Docket Item # 15
BAR CASE # 2007-0243

BAR Meeting
December 6, 2007

ISSUE: Re-Approval of Addition and Alterations, and Waiver of required HVAC Screening

LOCATION: 200 South Peyton Street

Figure 1: Proposed Peyton Street Elevation.

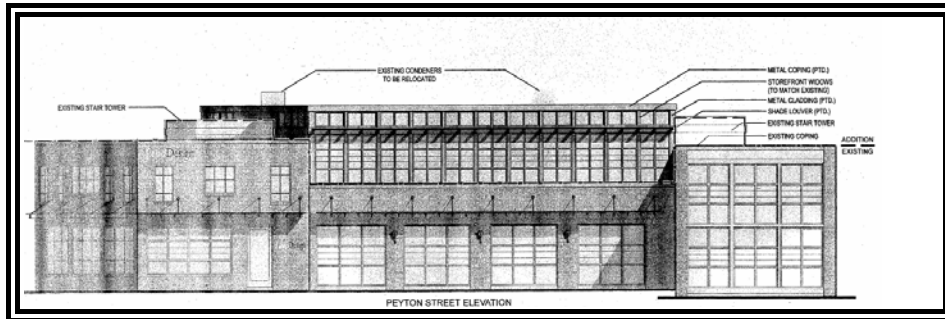
The addition will mimic the industrial aesthetic of the original building but will have subtle differences in the window configuration to distinguish it as a new addition. Metal storefront windows will be used on the addition and will match the existing windows used in the 2004 alterations. On the S. Peyton Street elevation, windows will be located in 11 bays, with typical widths of 4' 10", and reflect the configuration found on the existing building. Above the main bank of windows, a metal shade louver will be located, with a transom-style window above. Metal copings will be used at the rooflines. The addition will be clad in metal to match the metal on the existing building.

Figure 3: Proposed Commerce Street

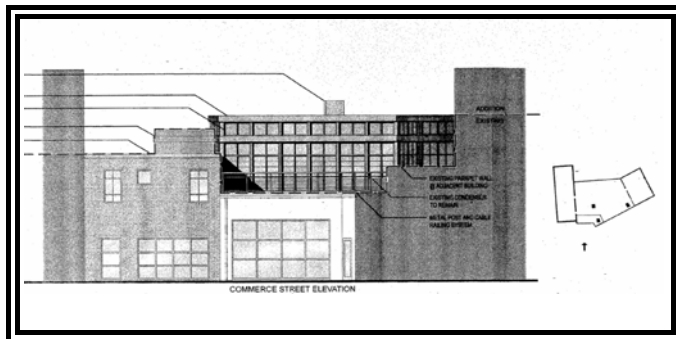
On the Commerce Street elevation facing the parking lot, the addition will have the same windows but not the metal shade louver. A metal post and cable railing system will provide railing for the roof-top deck area that overlooks the rear parking lot.
